FOUR OAKS ADDITION

SEDGWICK COUNTY, KANSAS

RE: S/D 98-123 -- One-Step Final Plat of FOUR OAKS ADDITION

RE: S/D 98-123 -- One-Step Final Plat of FOUR OAKS ADDITION

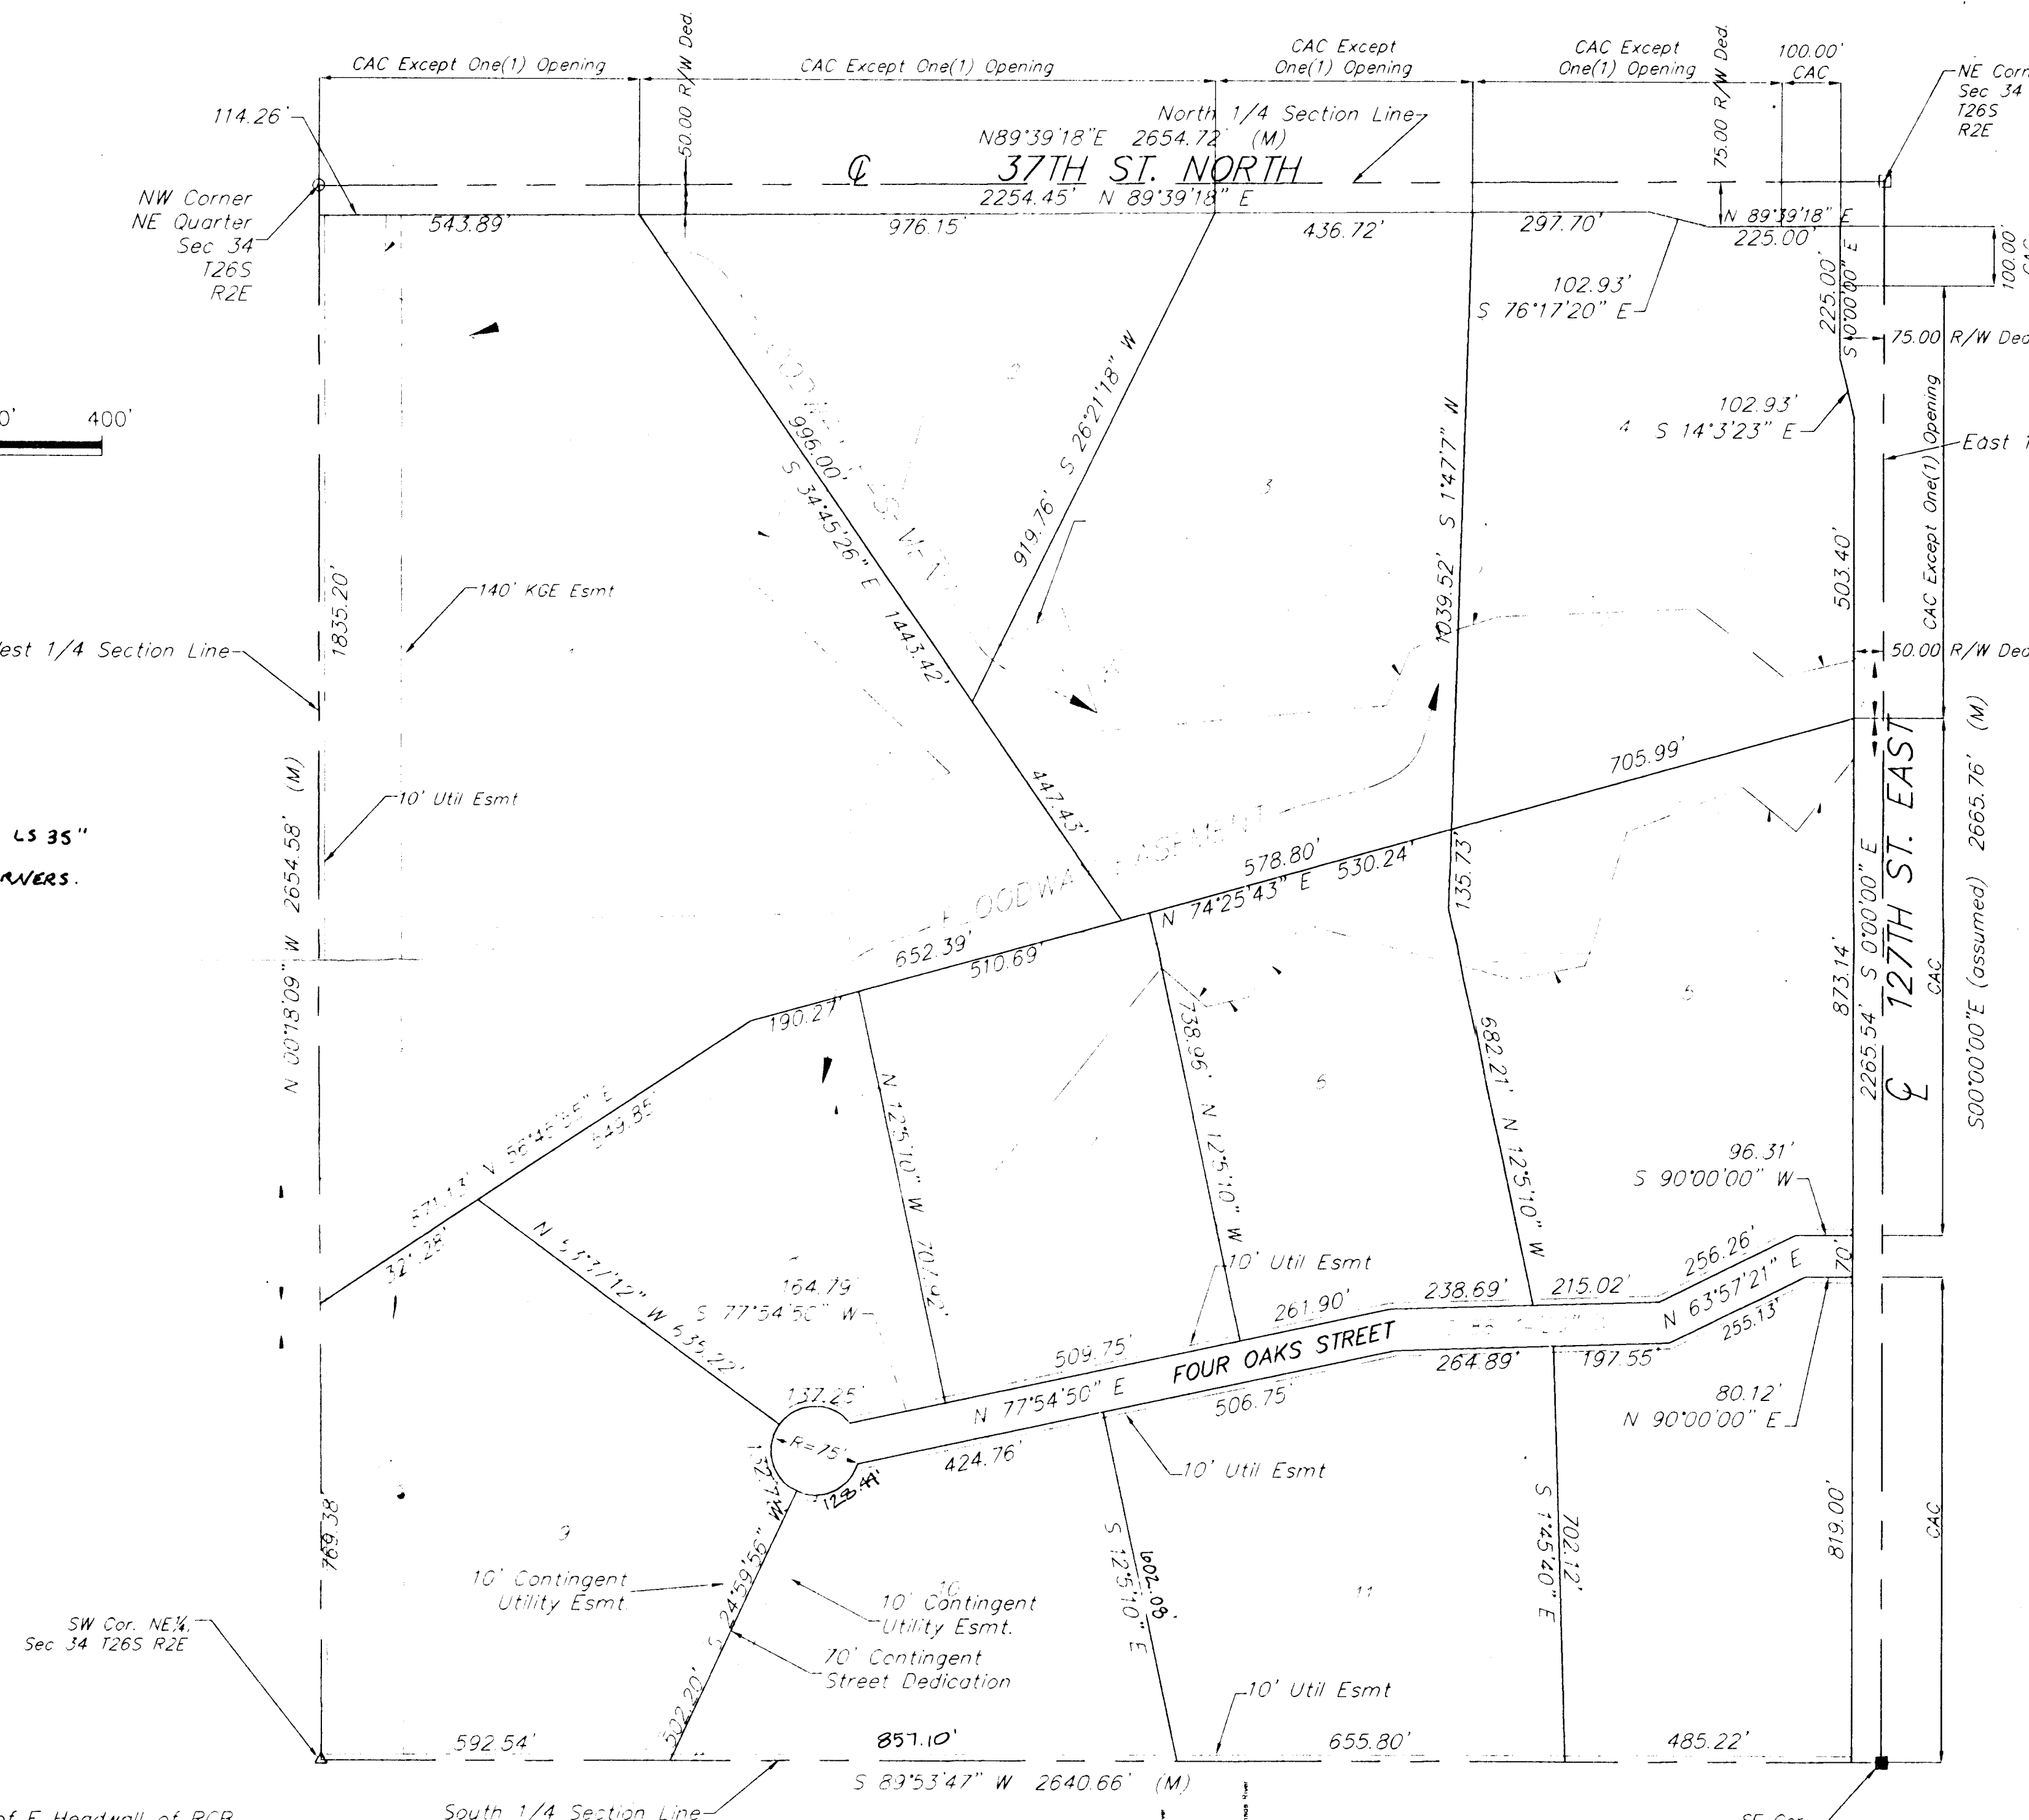
- D. County Engineering needs to comment on the status of the applicant's drainage plan. The floodway reserves need to be denoted.
- E. The final plat tracing shall denote complete access control along 127th St. East for Lots 5 and 12. Access controls denoting one access opening per lot is requested for the lots abutting 37th St. North. County Engineering needs to comment on any additional access controls at the intersections. The final plat tracing shall reference the access controls in the plat's text. County Engineering requires 100 feet of complete access control from each intersection.

- F. County Engineering needs to comment on the need for right-of-way for perimeter streets, in addition to the need for a major intersection right-of-way. The plat currently denotes a 25-ft half street right-of-way. The Subdivision regulations require at least a 50-ft half street right-

of-way for section line roads. County Engineering requires 50-ft rights-of-ways for perimeter roads, in addition to a 75-ft major intersection right-of-way.

- ✓ K. The plat shall reference a tie point to a section corner.
- ✓ L. The owner's certifications shall reference "lots and a street".
- ✓ M. Since the site is located within three miles of Wichita's City limits, the City Council signature block needs to be added.

- N. Bill Hancock shall be identified as "Chairman Pro Tem".
- O. County Fire should comment on the length of the new interior street which is approximately 1,900 feet in length exceeding the 1,200-ft limit imposed by the Subdivision regulations.

- ✓ P. The turnaround of the interior street should be increased to a 150-ft diameter.
- ✓ Q. A contingent right-of-way should be dedicated between lots 9 and 10 for future access to adjoining properties at the south line of the plat. The platlor's text shall reference the dedication.

- ✓ T. The final plat tracing shall indicate bearings for all side lot lines which are not at right angles with or radial to adjacent street lines.
- ✓ U. The applicant shall install or guarantee the installation of all utilities and facilities which are applicable and described in Article 8 of the MAPC Subdivision Regulations. (Water service and fire hydrants required by Article 8 for fire protection shall be as per the direction and approval of the Chief of the Fire Department.)
